Tender for: Barry Road & Coot Pond Road
Realignment, St. Georges Parish

Addendum #1

June 26, 2017

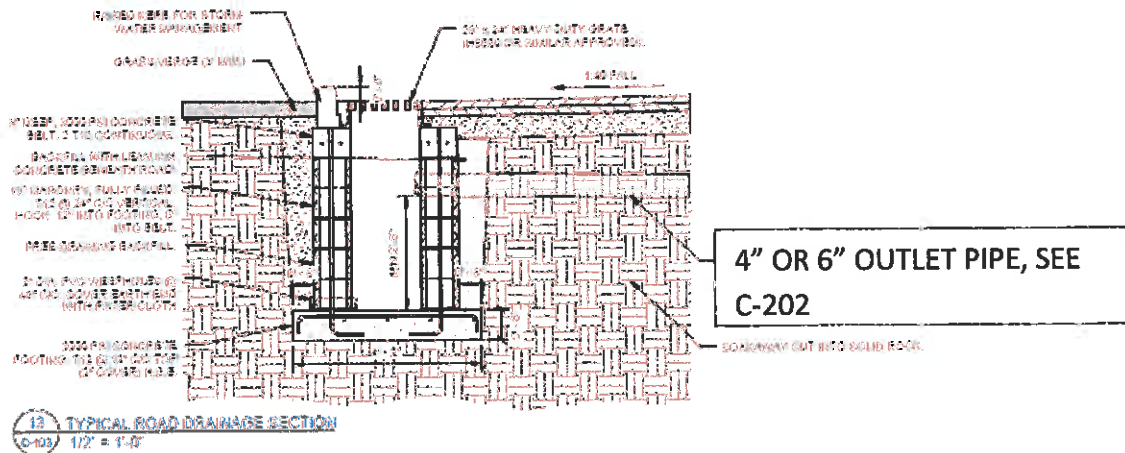
1. All duct lines shall be supplied by Contractor.
2. Light poles to be installed by BELCO. Contractor to install duct line under sidewalk per detail below amended C-103 detail 14.
